ELECTRONICS INDUSTRY PUBLIC COMPANY LIMITED

Product Change Notification

Change in Package design

Package Outline Comparison

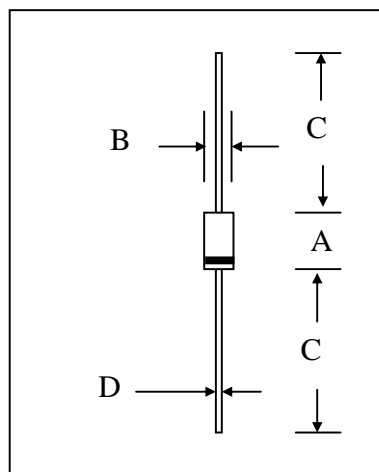
Effective on Jan 3, 2009, the Package change will be made to the product series as follows:

1N53xx Series - change the package from D2A to DO-15

P6KE Series - change the package from D2A to DO-15

BZW06 Series - change the package from D2 to DO-15
